A7. POST-APPLICATION DISCUSSION

COMMENTS BY THE PRIMROSE HILL CONSERVATION AREA ADVISORY COMMITTEE

Primrose Hill Primary School Princess Road NW1 8JL Listed Building PRE-APP

LB PLANNING AND CONSERVATION

Job	Drawing No	Rev
PHPS	PR122	G

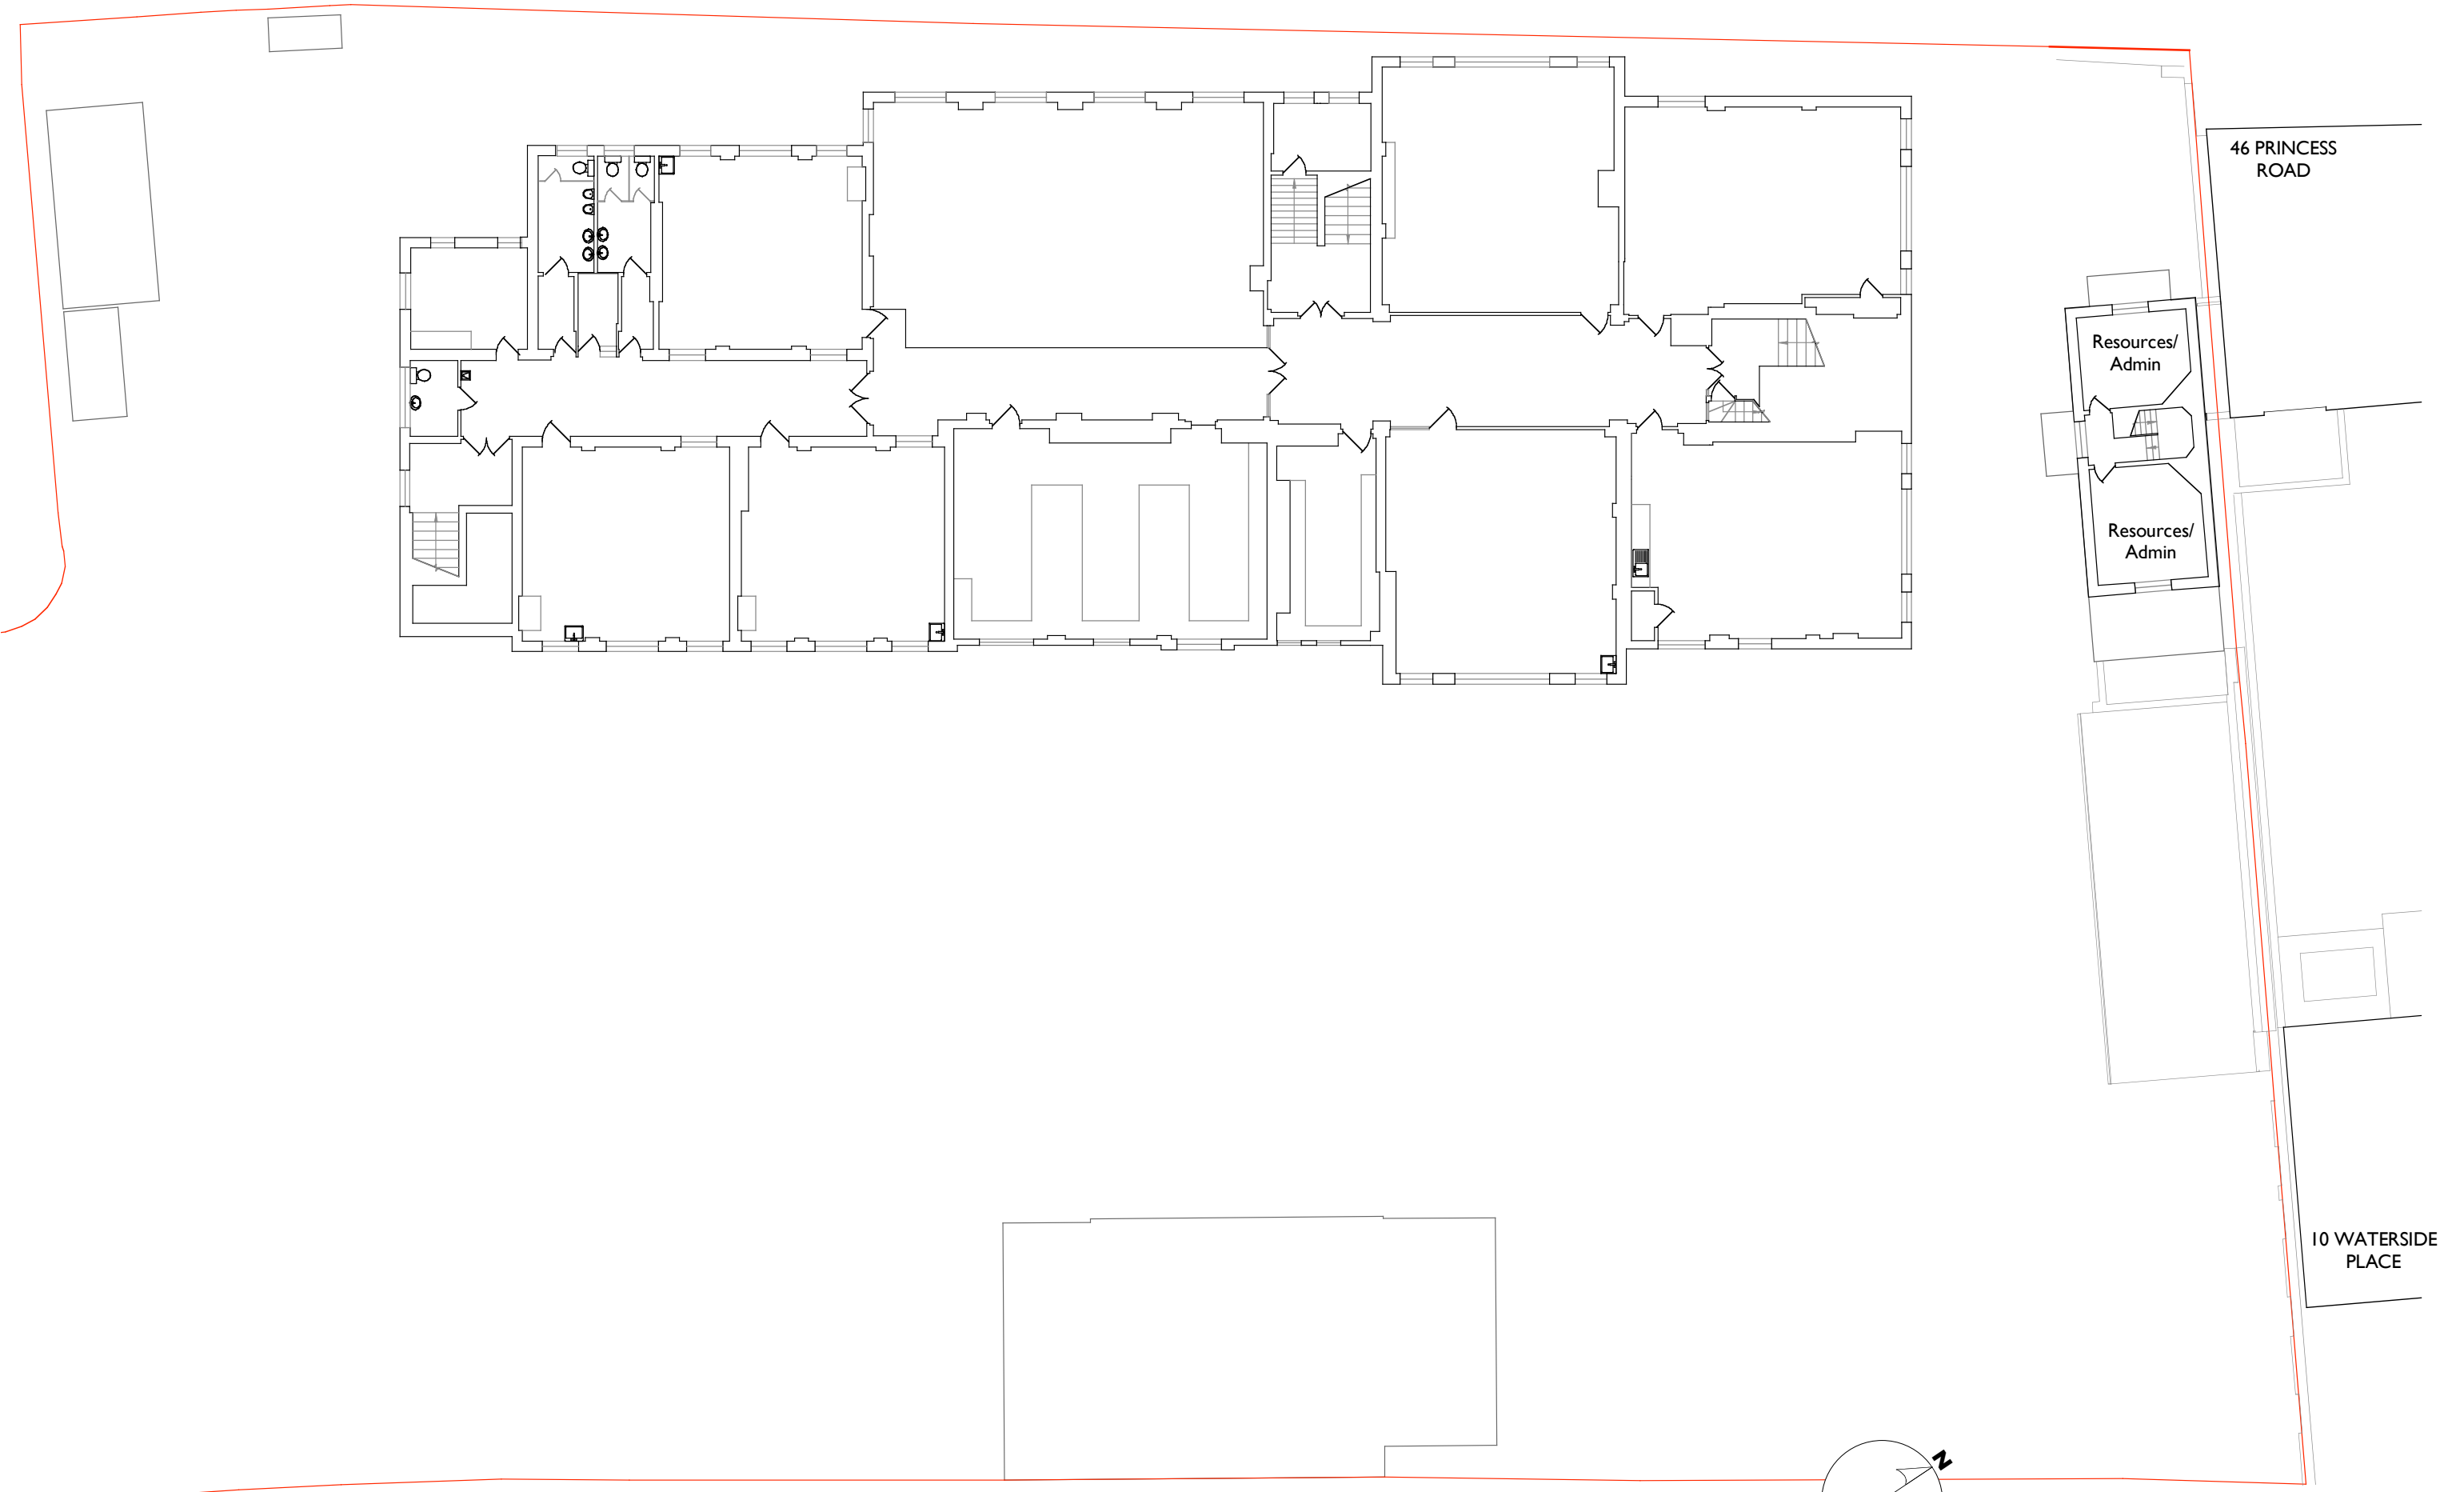
22. Confirmation of proposed numbers of two year-old provision.

Response: There are two phases for the introduction of two year-old provision at Primrose Hill School. In January 2017 the first phase will take twelve children and will use the street level floor of the Caretaker’s House. Depending on take up and interest the second floor may commence the following academic year, taking a further eight children on the first floor level. The top (second) floor of the Caretaker’s House will remain as a resource for the School staff and professionals who work with the children at the school..
There are no proposed changes to the layout or fabric of the first floor. Existing and proposed upper floor plans of the Caretaker’s House are attached below: PRPS EX 120_G, PRPS PR 122_G and PRPS EX 130_G.

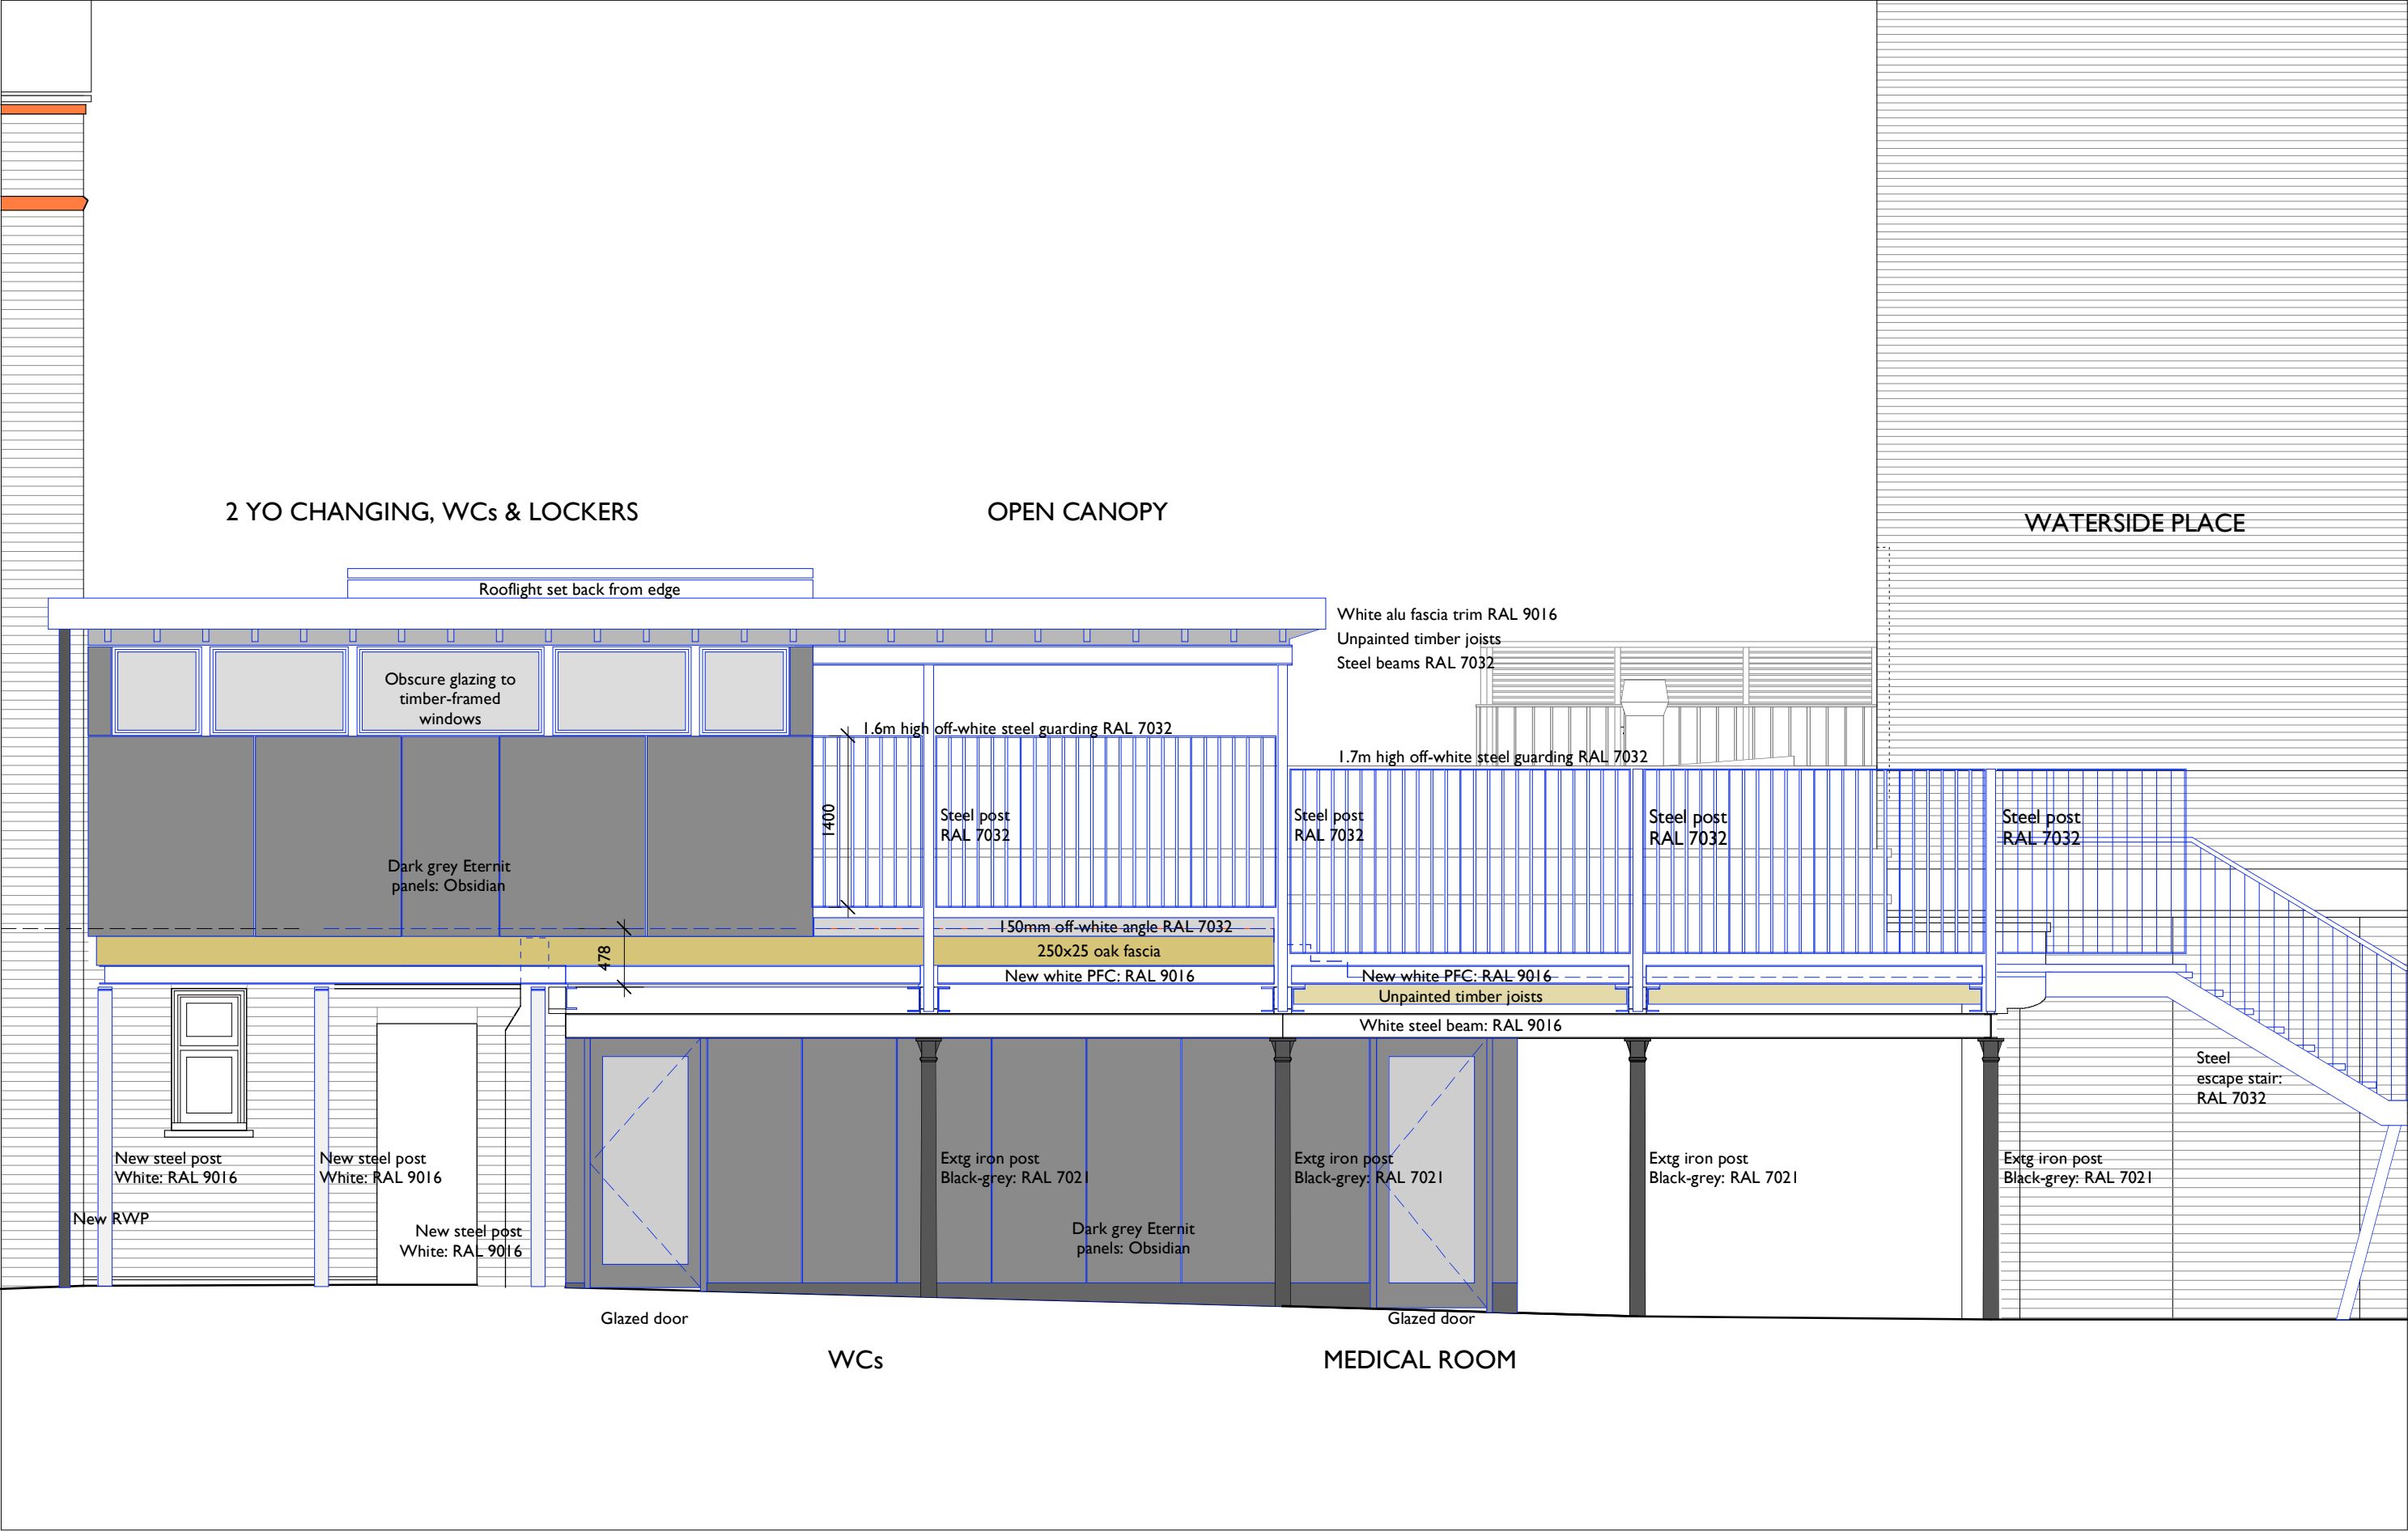
- 3. 'Open detail' to junction of new extension and rear corner of Caretaker's House.

17. 1:10 Details of guarding around 2YO terrace to be provided. More ‘open’ design to be considered than 60x10 uprights so visibility isn’t lost so quickly when viewed obliquely.

A detail incorporating a 38mm 'shadow gap' that reveals the corner bricks has been considered and incorporated in drawings PHPS PR 312_G and PHPS PR 412_G.

Response: Further details at 1:10 of the guarding around the 2YO terrace are provided. Guarding uprights have been revised to be predominantly circular bars to provide better oblique visibility. Every sixth upright is a flat, and this sub-division of panels will give a visual rhythm to the outside view of the terrace.
Drawings attached below: PRPS PR 412_G, PRPS PR506_G and PRPS PR 507_G.

Job	Drawing No	Rev
PHPS	PR242	G

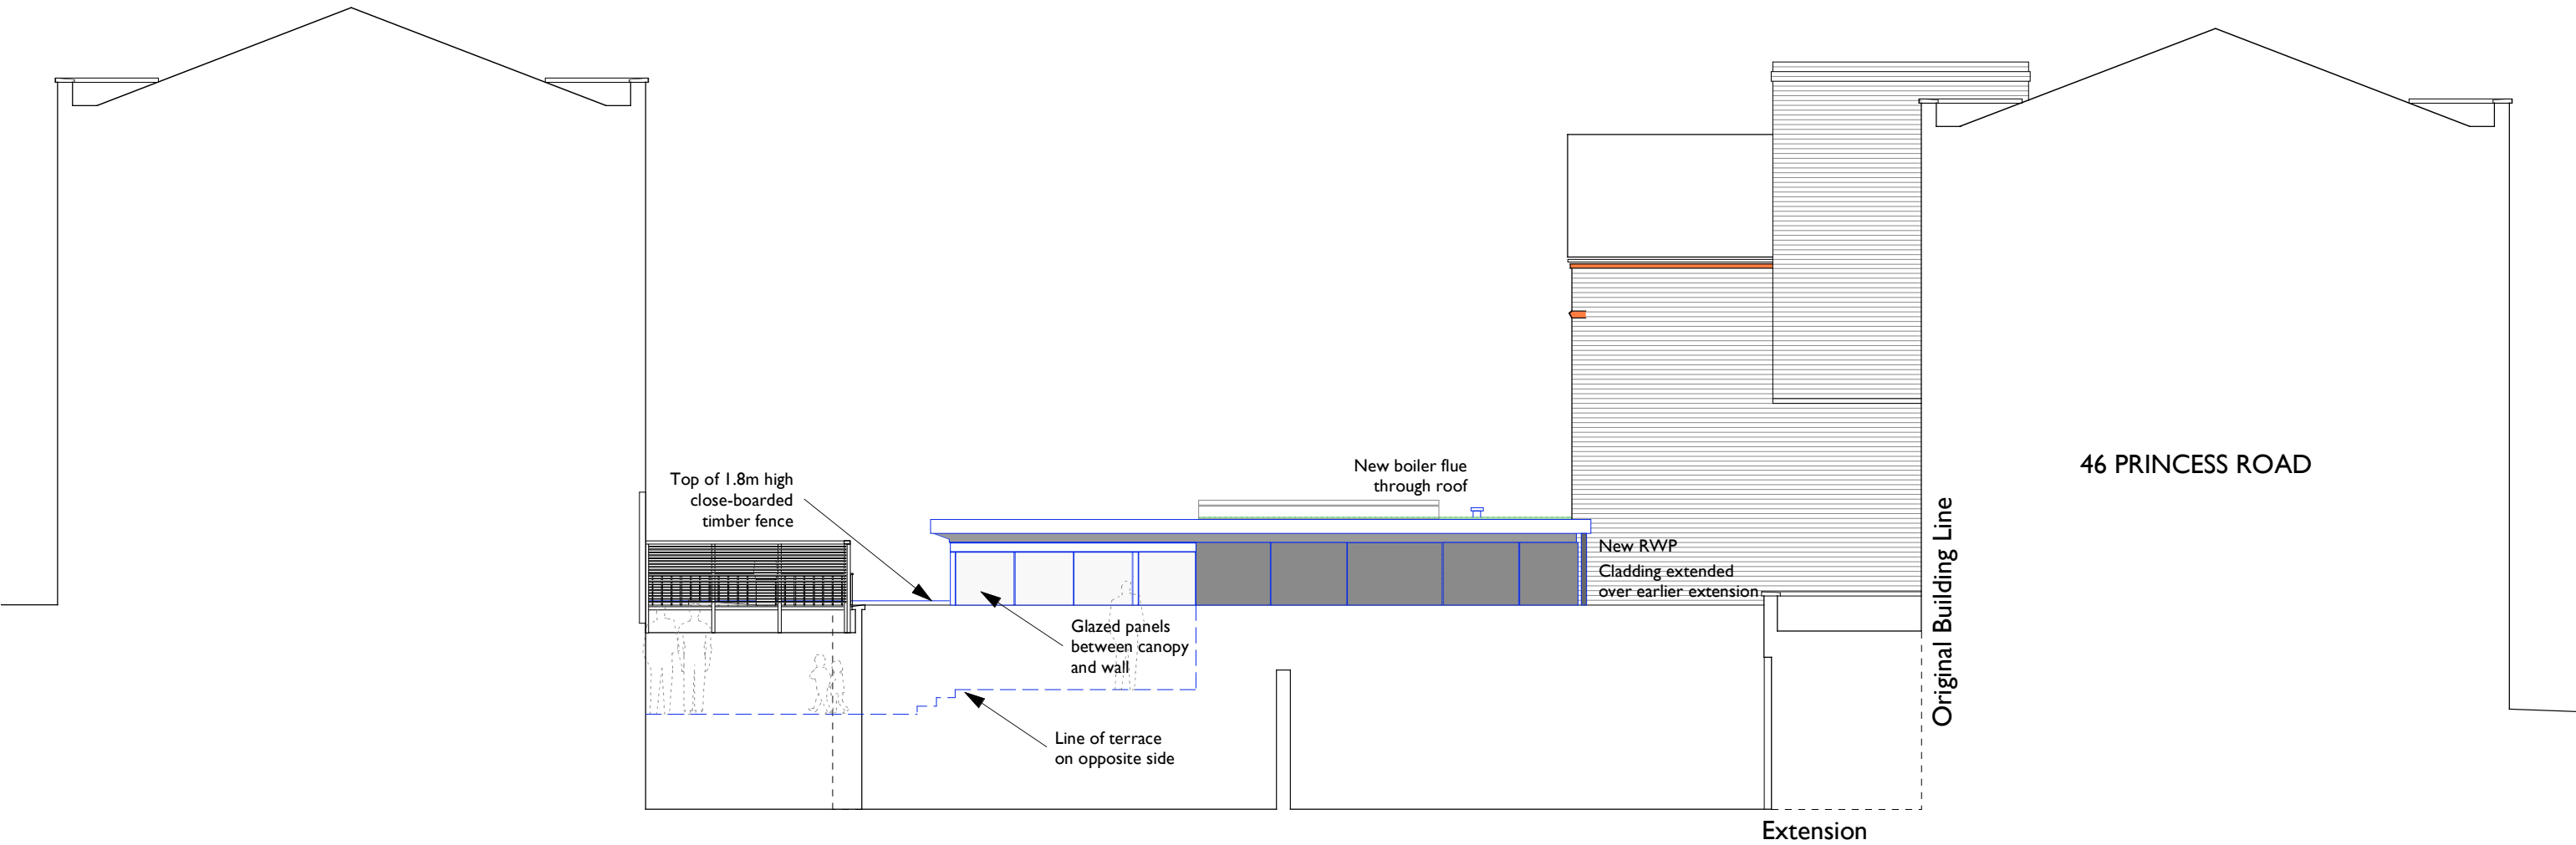
18. Concern about the visual effect of the Eternit cladding to neighbours’ side & the messy appearance of an extension on an extension. Consider a green/ living wall.

20. Annotations to drawings to be added and dot-on terrace deck height on neighbours’ elevation.

Response: The cladding panels along the boundary to Waterside Place have been extended over the brickwork of the 1939 extension to present a less fussy appearance to Waterside Place. Obscure glazed panels are fitted between the canopy and boundary wall to provide privacy and baffle sound from the upper terrace level.
Drawings attached below: PRPS PR 242_G, PRPS PR 312_G and PRPS 505_G.

Response: Annotations to drawings have been added and the terrace deck height is shown dotted on neighbours elevation. Neighbours’ boiler boiler flue and terrace enclosure have been added to drawings.
Drawing attached below: PRPS_PR 242_G.
